# UNITED STATES PATENT AND TRADEMARK OFFICE

APPLICATION NO.	FILING DATE	FIRST NAMED INVENTOR	ATTORNEY DOCKET NO.	CONFIRMATION NO.
10/790,524	03/01/2004	Douglas P. Gethmann	06005/39970	2733

<b>Office Action Summary</b>	<b>Application No.</b> 10/790,524	<b>Applicant(s)</b> GETHMANN, DOUGLAS P.	
	<b>Examiner</b> Ernesto Garcia	<b>Art Unit</b> 3679

Warren, 335,259

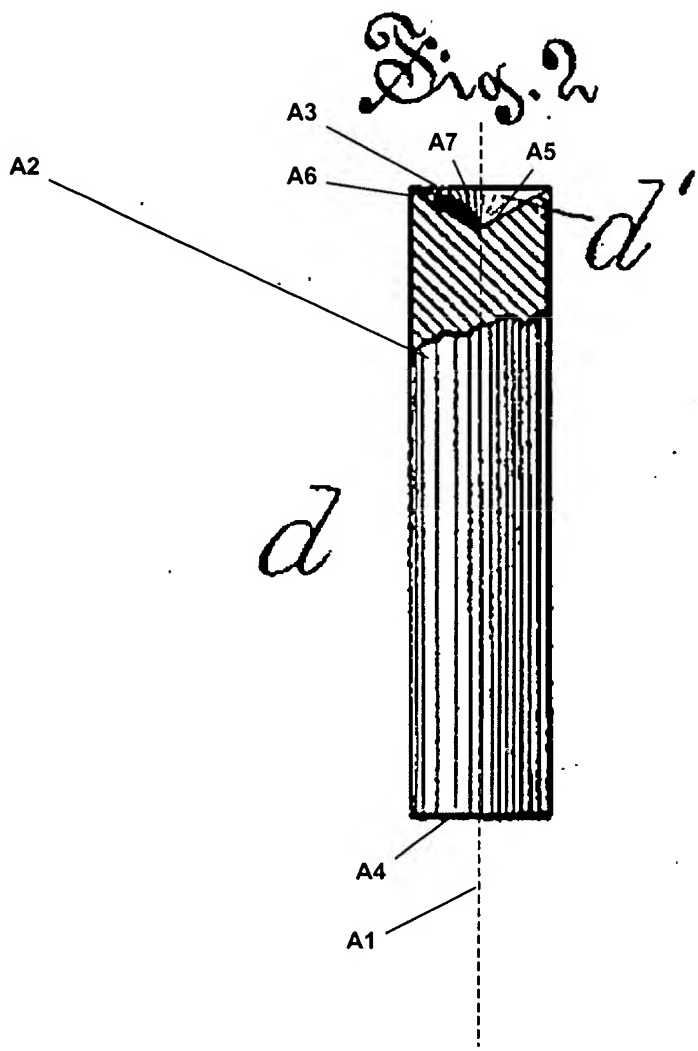
Regarding claim 24, Warren discloses, in Figures 1 and 2, a locking mechanism comprising a valve stem extension **a** and a generally cylindrical body **d**. The extension **a** has a tip **c** and a male thread **b**. The cylindrical body **d** has a longitudinal axis **A1** (see marked-up attachment). The body **d** includes a non-threaded outer side surface **A2**, a first axial end **A3**, and a second axial end **A4**. A wedge **d'** is formed adjacent the first axial end **A3**. The wedge **d'** includes an inner engagement surface **A5**. The wedge **d'** further includes a non-threaded outer engagement surface **A6**. The wedge **d'** is sufficiently pliant.

Regarding claim 2, the wedge **d'** forms a continuous rim extending around the first axial end. The rim **2** has a triangular cross-section.

Regarding claim 3, a central portion of the first axial end **A3** defines a cavity **A7** that forms the inner engagement surface **A5**.

Regarding claim 4, the cavity **A7** has a cone shape.

Regarding claim 5, the cone shape has a vertex angle of approximately 120 degrees.

Regarding claim 6, the wedge **d'** is able to deform radially outward as an insertion force is applied to stem extension **a**.

Regarding claim 7, the body and the stem extension are formed of a similar material (note that the cross hatching is metal for the components).

Schobbe, 4,498,680

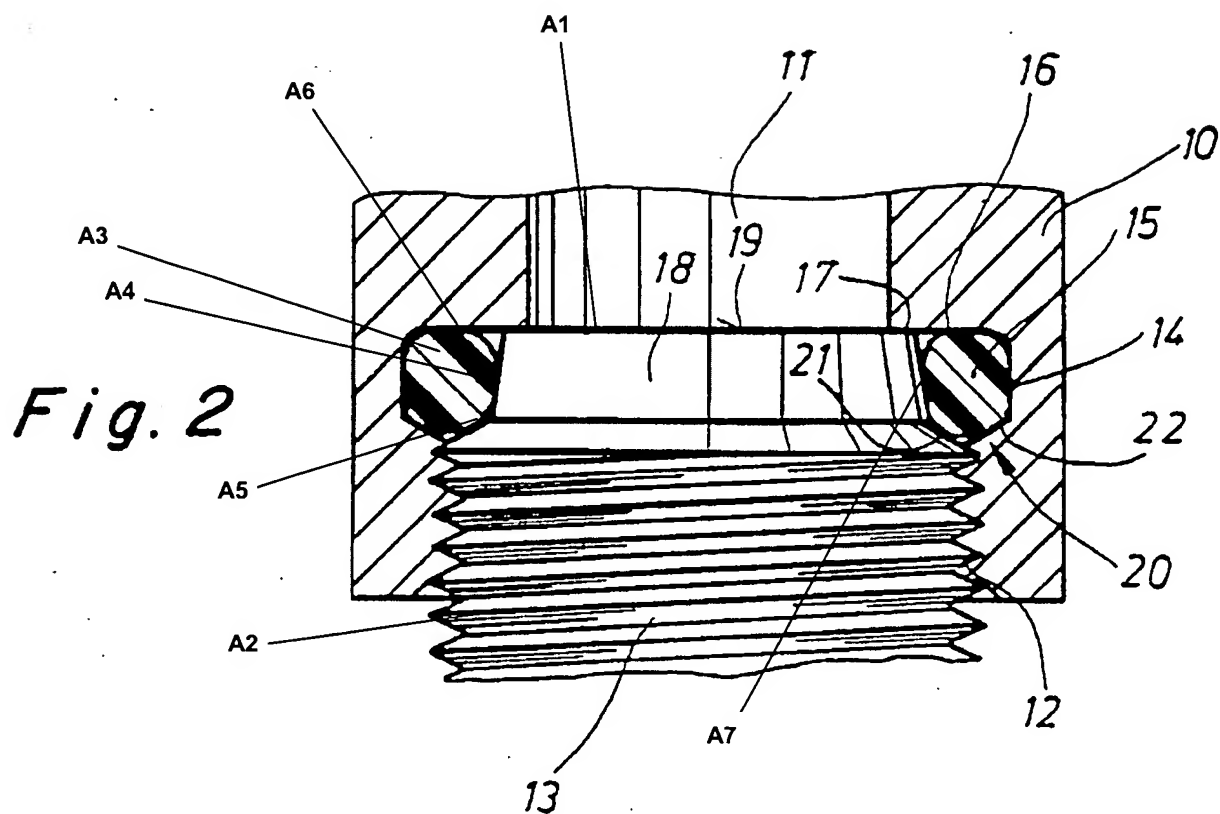
Regarding claim 9, Schobbe discloses, in Figure 2, a locking assembly comprising a first connection member **13**, a second connection member **10**, and a locking mechanism **15**. The first connection member **13** defines an insertion end **A1** (see marked-up attachment) formed with a male thread **A2**. The second connection member **10** defines an aperture **11** formed with a female thread **12** complementary to the male thread **A2**. The locking mechanism **15** comprises a body **A3** and a continuous wedge **A4**. The body **A3** extends along an axis and has an outer side surface **14**. The body **15** defines a first axial end **A5** and a second axial end **A6**. The wedge **A4** projects

from the first axial end **A5**. The wedge **A4** has an inner engagement surface **A7** and a substantially non-threaded outer engagement surface. The inner engagement surface **A7** engages the insertion end **A1** of the first connection member **13**. The wedge **A4** is sufficiently pliant.

Regarding claim 10, the first connection member **13** comprises an extension stem, and the second connection member **10** comprises a valve actuator rod.

Regarding claim 11, the wedge **A4** forms a continuous rim extending around the first axial end **A5**.

Regarding claim 12, a central portion of the first axial end **A5** defines a cavity (the opening) that forms the inner engagement surface **15**.
